**Prepared by: Acoustical Technologies Inc.
 50 Myrock Avenue
 Waterford, CT 06385-3008**

**Subject: Mayflower Special Permit Application
 116 Woodbury Road
 Washington, CT 06793
 Airborne Acoustic Analysis**

Date: January 20, 2022

Figure 5. Diffraction Estimate at 23 Wykeham Rd for Music Shed with Source Centered in Shed

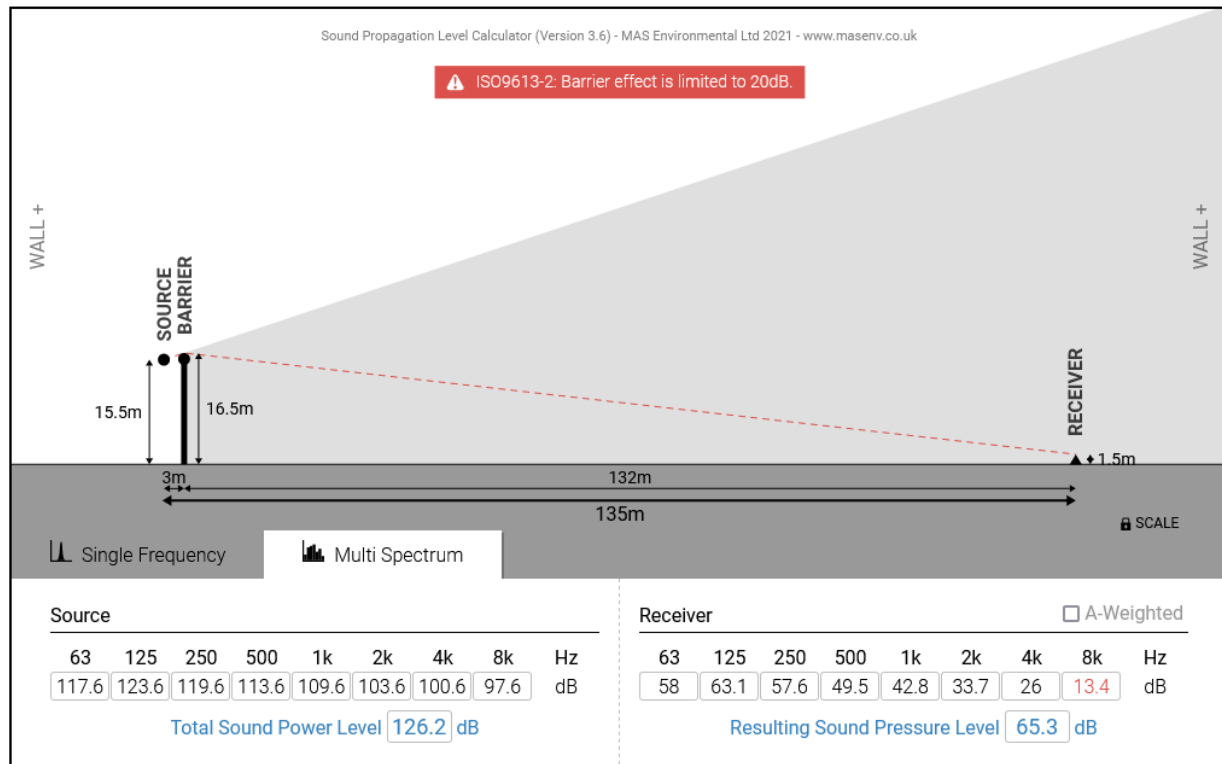
Another very important issue of concern is the music that is diffracted around the edge of the music shed. Assume that we turn off the multiple small format loudspeakers that are in the tent and just look at the sound directly leaving the music shed. Some of that sound will diffract around the west edge of the shed and head towards the nearby neighbors. This diffraction is depicted in Figure 5. We assume the shed is about 20 feet wide and the source is in the center about 1 meter back from the front edge of the shed. Figure 5 shows that the level at the closest neighbor has dropped from 75.4 dBA to 65.3 dBA. If we add another 10 dB for the absorber material on the tent walls the result is about 55 dBA, not the 35 dBA that was predicted in reference 2. If we move the source further back from the edge by a half meter the noise level at 23 Wykeham only drops by 1 dB. If we move the source from the middle to 5 feet from the west edge the noise level at 23 Wykeham again only drops by 1 dB. Because of the diffraction around the west edge, the shed is probably capable of only about a 10 dB improvement over not having a shed. This means that by this mitigation approach only a 20 dB total improvement is possible. The nearest neighbors would see 55 dBA levels, near or just below the daytime CT noise limit.

Given that the noise mitigation will probably be no more than 20 dB the only way to achieve the 35 dBA level at the nearest house will be to turn down the music within the tent using the musical entertainment management program. The 100 dBA at 5 feet will need to be lowered to about 80 dBA at 5 feet. Unfortunately, that level of sound is probably near or below the level of speaking noise generated by the 120 people in the tent. Music at 80 dBA at 5 feet is not going to work. The noise mitigation should be increased from the proposed 20 dB to about 40 dB.
